To: T10 Technical Committee
From: Robert Sheffield (Robert.L.Sheffield@intel.com), Intel Corporation
Date: November 10, 2003
Subject: T10/03-273r2 SAS-1.1 Support for SATA Port Selector

Revision 2 (November 10, 2003): Modify as directed by November SAS Protocol WG for approval.

Figure 59 – SATA port selection signal

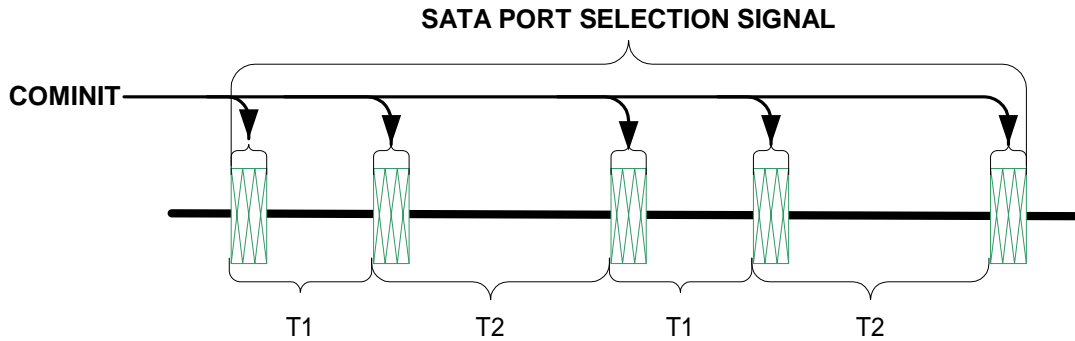
Add the following text and figure after the last paragraph in sub clause 6.5 Out of band (OOB) signals:

The SATA PORT SELECTION SIGNAL shown in figure 59 causes the attached SATA port selector to select the attached phy as the active phy (see the SATA-II Port Selector Specification). The generated SATA PORT SELECTION SIGNAL shall be composed of 5 COMINIT signals, each starting a specified time interval, T1 or T2 as shown in Figure 59, after the start of the previous COMINIT signal. The values of T1 and T2 shall be as shown in Table 1.

Table 1 - Intervals between COMINIT in the SATA PORT SELECTION signal

Interval	Value (OOBI)
T1	3.0x10 ⁶
T2	12x10 ⁶

Figure 70 - SP (phy layer) state machine – SATA_PortSelectionSignalPending state

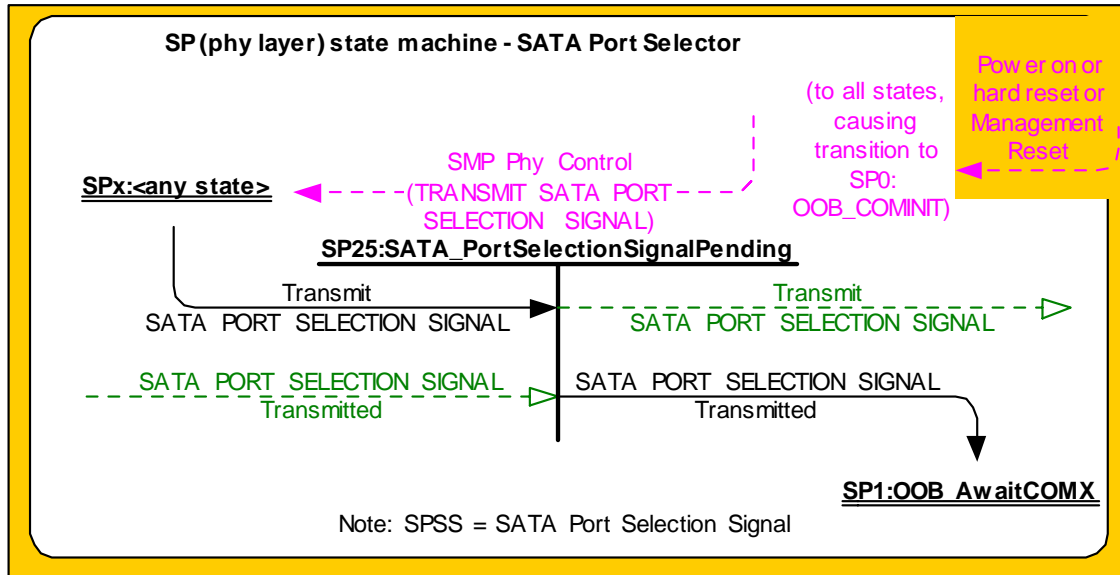
Add sub clause 6.7.6 as follows:

Figure 70 shows the SATA_PortSelectionSignalPending state. This state controls transmission of the SATA Port Selection signal when a specified phy processes an SMP Phy Control (TRANSMIT SATA PORT SELECTION SIGNAL) request.

6.7.6.1 Transition SPx:<any state> to SP25:SATA_PortSelectionSignalPending

If the phy supports attachment of a SATA device and attachment of a SATA Port Selector, a transition shall occur from any SP state to this state upon receipt of an SMP Phy Control function for the phy specifying a PHY OPERATION of TRANSMIT SATA PORT SELECTION SIGNAL. The phy shall transmit the SATA PORT SELECTION SIGNAL (see table 163 – phy operation and sub clause 6.5 – out of band signals). This transition shall clear the ATTACHED SATA PORT SELECTOR bit in the DISCOVER Response.

6.7.6.2 Transition SP25:SATA_PortSelectionSignalPending to SP1:OOB_AwaitCOMX

This transition shall occur when the phy completes transmission of the SATA PORT SELECTION signal (SATA Port Selection Signal Transmitted).
